Item Name: Replacement Skidtube, High Gear with Standard Wearplates Fits LH or RH

DESIGN	DS	DART AEROSPACE USA, INC	
DRAWN	AJS	PORT HADLOCK, WA	
CHECKED		DRAWING NO.	REV. F
MFG. APPR.		D2650	SHEET 2 OF 6
APPROVED		TITLE	SCALE
DE APPR.		206/407 SKIDTUBE ASSEMBLIES	NTS
DATE	08.08.08	COPYRIGHT © 1997 BY DART AEROSPACE USA, INC	
THIS DOCUMENT IS PRIVATE AND CONFIDENTIAL AND IS SUPPLIED ON THE EXPRESS CONDITION THAT IT IS NOT TO BE USED FOR ANY PURPOSE OR COPIED OR COMMUNICATED TO ANY OTHER PERSON WITHOUT WRITTEN PERMISSION FROM DART AEROSPACE USA, INC.

DRAWING NO. D2650	TITLE 206/407 SKIDTUBE ASSEMBLIES	REV. F	DART AEROSPACE LTD ENGINEERING ORDER		D.E.O. NO. D2650-F-1	SHEET NO. SHEET 1 OF 1	SCALE NTS
DRAWN <i>[Signature]</i>	CHECKED A.P.	MFG. APPR. <i>[Signature]</i>	APPROVED <i>[Signature]</i>		DE APPR. <i>[Signature]</i>		
DATE 12.10.12	DATE 12.10.22	DATE 12.10.22	DATE 12.10.22		DATE 12.10.22

CHANGE C'BORED WELDED CROSSBOLT SPACERS TO SWAGED SPACERS

DETAIL G

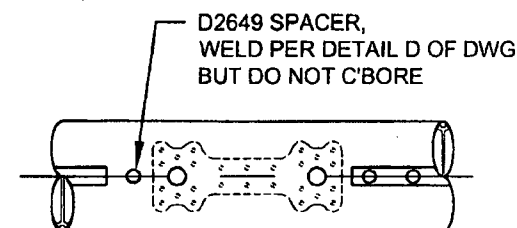
ADD DETAIL G BELOW, WHICH IS THE SAME SECTION VIEW AS DETAIL D OF DWG.

C'BORED HOLES ARE NOW SWAGED PER DETAIL G BELOW. FOR THE Ø0.375 HOLE THAT IS NOT C'BORED, WELD PER DETAIL D OF DWG (SEE AMENDED DETAIL B FOR REFERENCE).
